UNITED STATES PATENT AND TRADEMARK OFFICE

| APPLICATION NO. | FILING DATE | FIRST NAMED INVENTOR | ATTORNEY DOCKET NO. | CONFIRMATION NO. |
|-----------------|-------------|---------------------------|---------------------|------------------|
| 10/024,784 | 12/20/2001 | Reinhold Wimberger-Friedl | NL 000774 | 3142 |

Office Action Summary

DETAILED ACTION

Figure 2 - U.S. Patent 5,866,265 to Reilly et al.

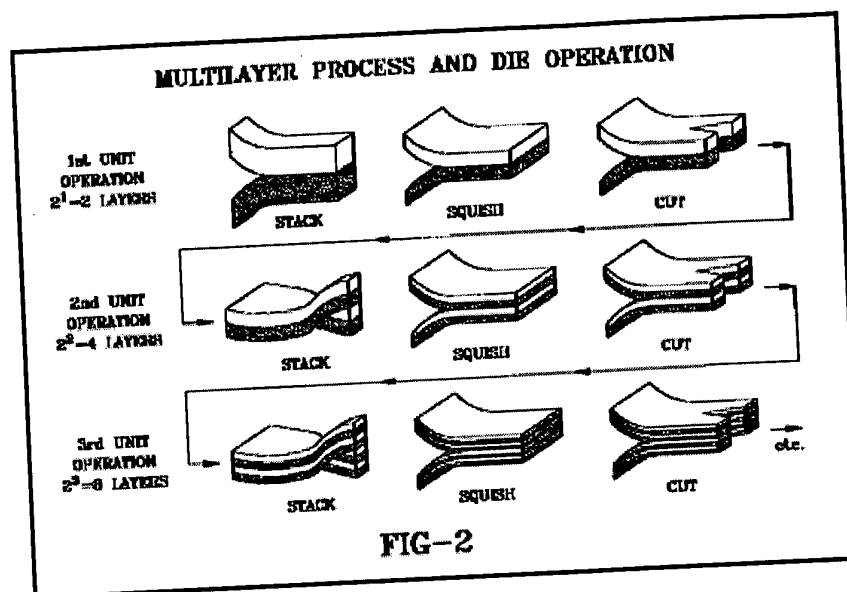
4. As per claim 1, Reilly et al. disclose a method of manufacture wherein material strips having different properties (column 3, lines 5-9; 48-59) are extruded to form regions of a grid structure (Fig. 2, above).

5. As per claim 2, Reilly et al. disclose a method of manufacture wherein material strips are co-extruded.

layers, thus forming an assembly of alternating material strips (see Fig. 2 above; column 3, lines 5-17).

Figure 1 - U.S. Patent 5,581,592 to Zarnoch et al.

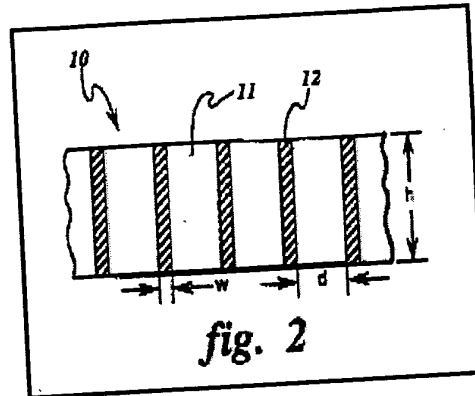
10. Zarnoch et al. disclose a grid structure (10) with successive regions having different X-ray absorption coefficients, the material strips (11, 12) having different X-ray absorbing behavior (abstract, column 3, lines 61-64).

11. It would have been obvious to modify the method of Reilly et al. such that the grid comprised successive regions having different X-ray absorption coefficients; and wherein the material strips possessed different X-ray absorbing behaviors. One would have been motivated to make such a modification so that the grid could be used for a user-determined application. Additionally, one would have been motivated to make such a modification so that the grid reduces scattered radiation by absorbing transmitted rays, thereby improving image quality as taught by Zarnoch et al. (column 3, lines 45-54; column 4, lines 60-63).

Figures 1-6 - U.S. Patent 3,919,599 to Stevens

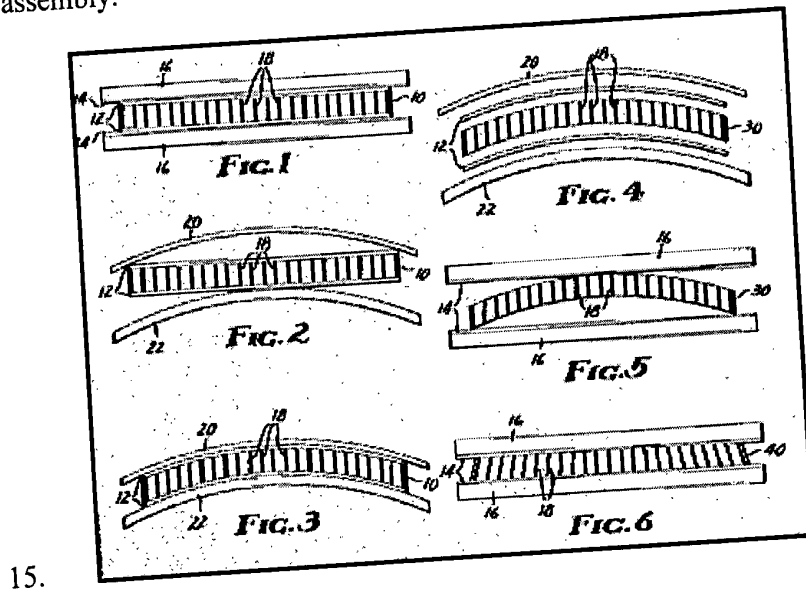
16. Stevens discloses a method of deforming a grid assembly (Figs. 1-3); the assembly subsequently subjected to a re-conversion into a flat assembly wherein neighboring regions remain in an inclined position relative to one another and focused to a centerline of the assembly (Figs. 4-6).

17. It would have been obvious to further modify the method of Reilly et al. such that it incorporated the steps of deforming the grid assembly in a direction transverse to a propagation direction and subsequently reconverting the assembly into a flat assembly, wherein neighboring regions remain in an inclined position relative to one another and focused to a centerline of the assembly. One would have been motivated to make such a modification so that the grid assembly is constructed to provide shaper focusing of incident radiation due to increased absorption of secondary radiation as taught by Stevens (column 1, lines 34-53).
